REMARKS

Claims 1-22 are pending. Claims 12 and 14 are rejected under 35 U.S.C. § 102(e). Claims 1-11, 13, 15-22 are rejected under 35 U.S.C. § 103(a).

TI-35949

FIG. 1 (PRIOR ART)

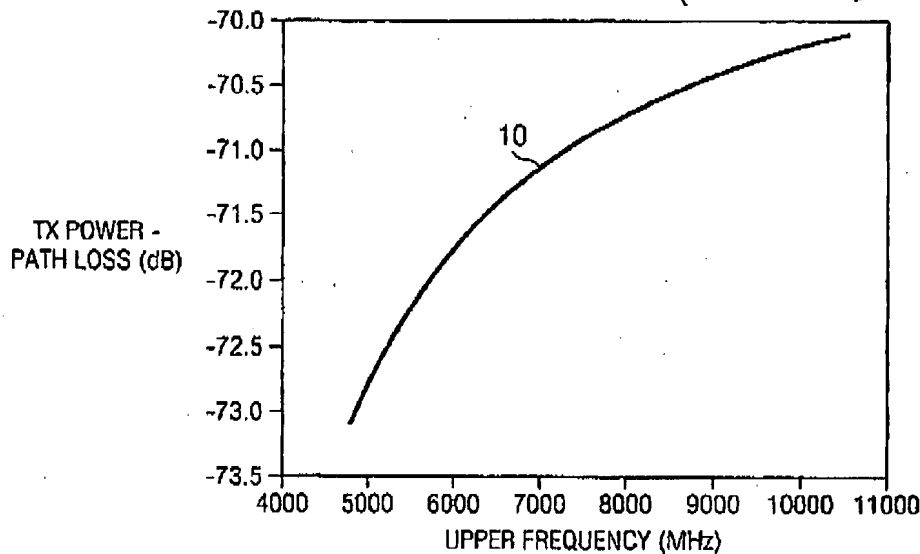
Examiner objects to Figures 1-2 of the drawings as not being designated "Prior Art." Applicants have included a marked up sheet (Annotated Sheet) indicating Figures 1-2 are Prior Art. Applicants have also included a "Replacement Sheet" indicating Figures 1-2 are Prior Art.

ANNOTATED SHEET
